Subject: Issuance of Amendment No. 10 to Facility Operating License No. NPF-38
for Waterford 3

ISSUANCE OF AMENDMENT NO. 10 TO FACILITY OPERATING
LICENSE NP. NPF-38 FOR WATERFORD 3

AMENDMENT TO FACILITY OPERATING LICENSE

SAFETY EVALUATION BY THE OFFICE OF NUCLEAR REACTOR REGULATION
SUPPORTING AMENDMENT NO. 10 TO FACILITY OPERATING LICENSE NO. NPF-38
LOUISIANA POWER AND LIGHT COMPANY
WATERFORD STEAM ELECTRIC STATION, UNIT 3
DOCKET NO. 50-382

FIGURE 3.1-1

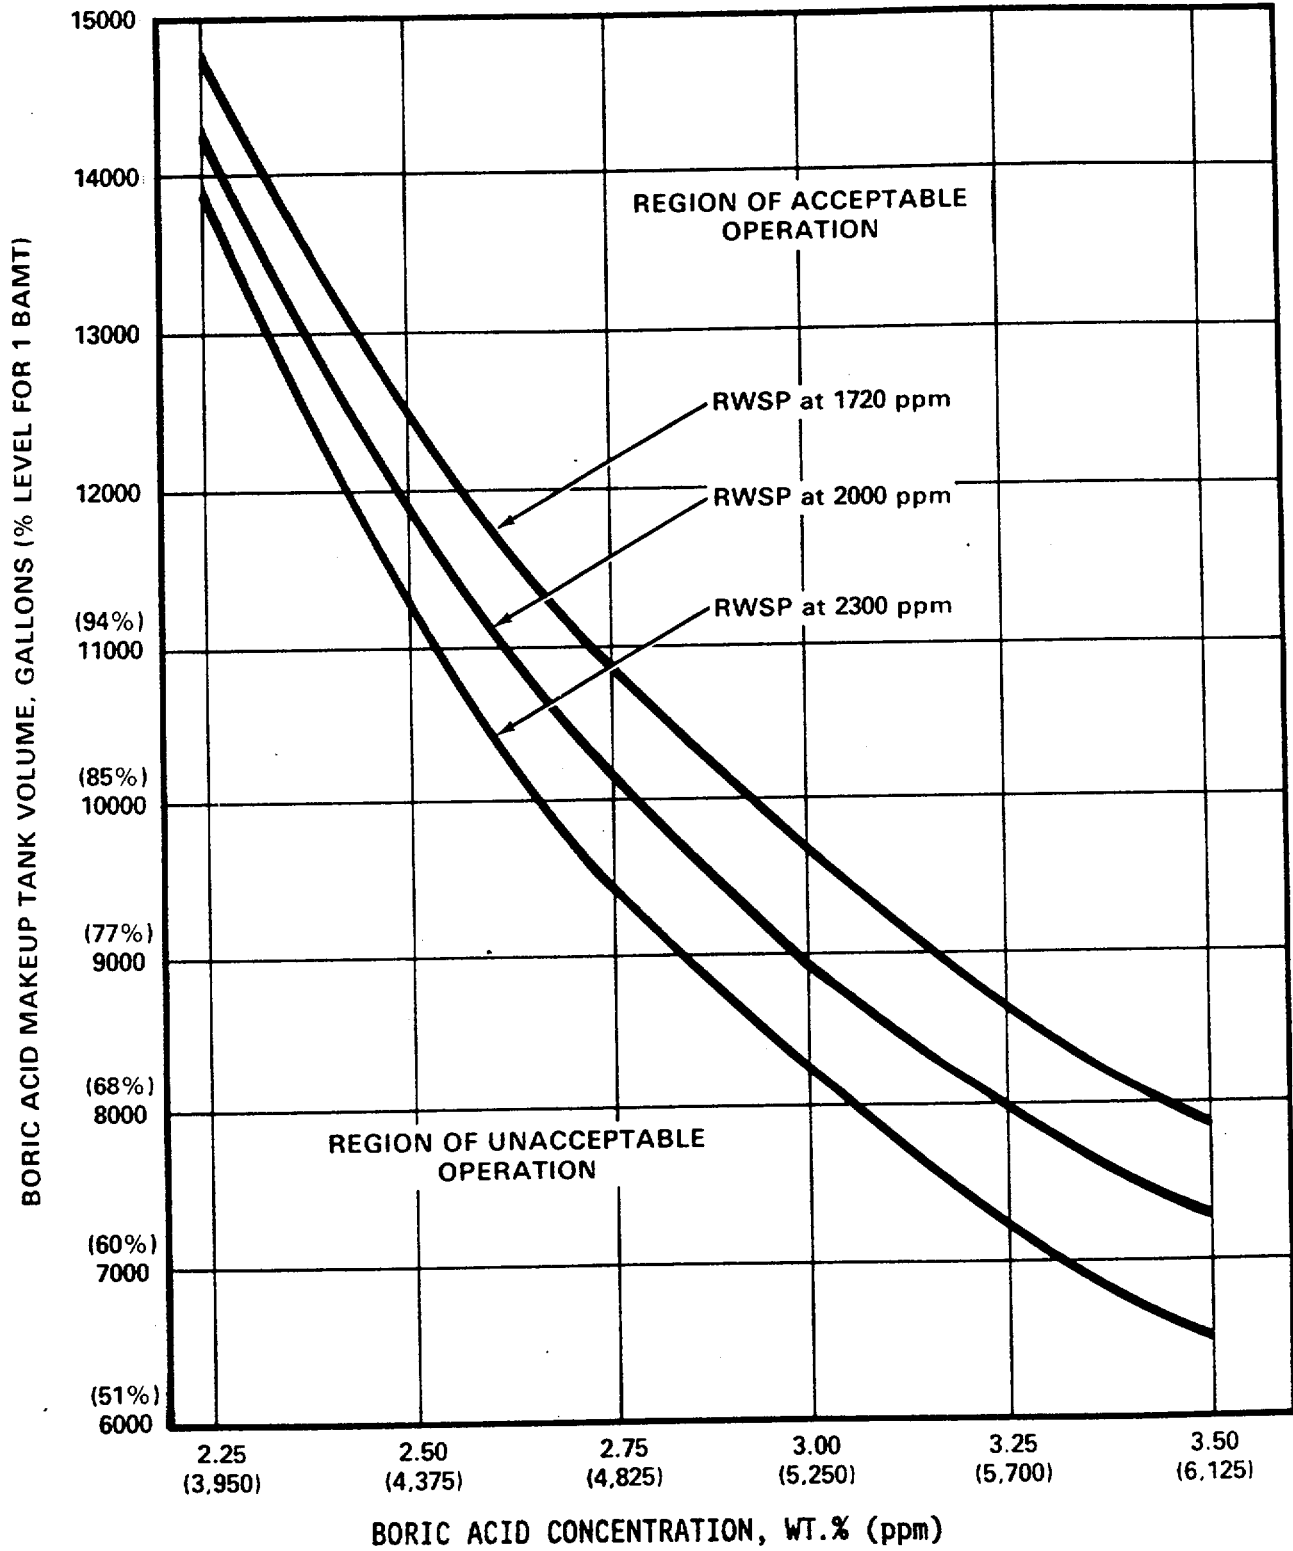
This figure specifies the minimum required BAMU water volume and temperature as a function of stored boric acid concentration for the various plant operating modes. The revised figure specifies the minimum required water volume (contained in one or both BAMU tanks) as a function of boric acid concentration for a given boron concentration in the RWSP. The range of boron concentration in the BAMU tank has been reduced from 7.5 to 12.0 weight percent boric acid to 2.25 to 3.5 weight percent. The upper range of the required borated water volume increases from 5,850 gallons to 14,800 gallons. The staff finds that the revised Figure 3.1-1 is consistent with the analytical results (as discussed in Section 2) for plant conditions at Operating Modes 1 through 4, maintains the required safe shutdown margin, and is therefore acceptable.

The existing Figure 3.1-1 specifies the volume of boric acid of 5,850 gallons at a minimum concentration of 7.5 weight percent to be maintained in the BAMU tank. The proposed changes are to reduce the

range of boric acid concentration for one or both BAMU tanks with an allowable water content as specified in the revised Figure 3.1-1. The staff concludes that the changes are acceptable since the revised Figure 3.1-1 is acceptable as discussed in the last section.
